SERVICE BULLETIN ASM-005

Product: Antenna System Monitor

Subject: Firmware 2.0 Release

- i) Activity Indicator (“Act”)

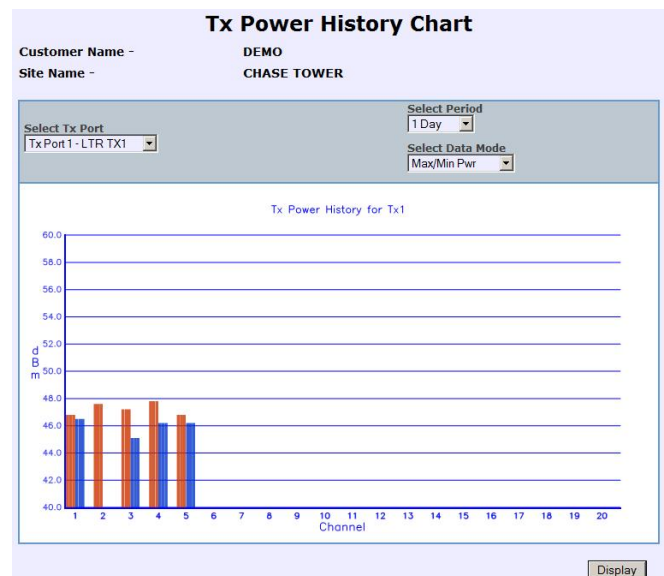
This feature provides an indication of the currency of the *Last recorded activity above threshold* value being displayed in the Status screens. If the Act indicator is lit, the value displayed was measured in the last measurement cycle. If the indicator is dim, the value displayed is aged. If the indicator is not displayed at all against any channel line, then that channel is currently disabled and is not being included in measurement cycles.

- ii) New History Chart

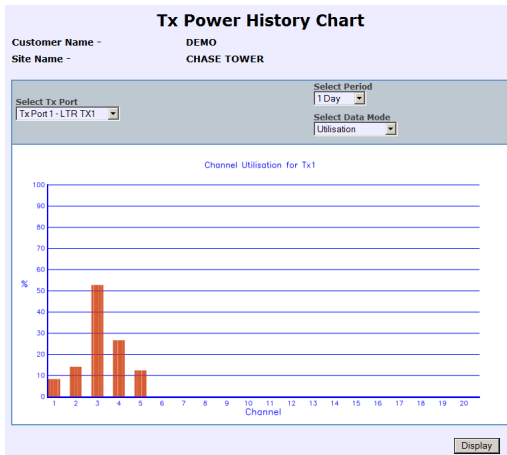
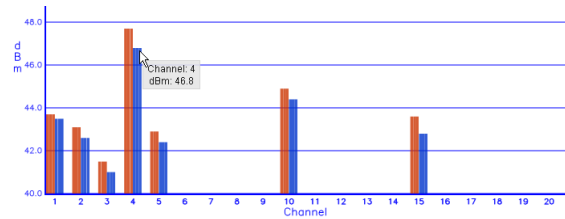
Two History Chart types are now available; Max/Min Power, and Channel Utilisation.

Max/Min shows the maximum and minimum Tx Power measured for each channel on the selected port – over the selected period. This data can indicate Tx PA power sag, combiner insertion loss drift, or other conditions that may be causing variable RF output power.

Hovering the mouse cursor over the upper portion of a bar will display its actual value.
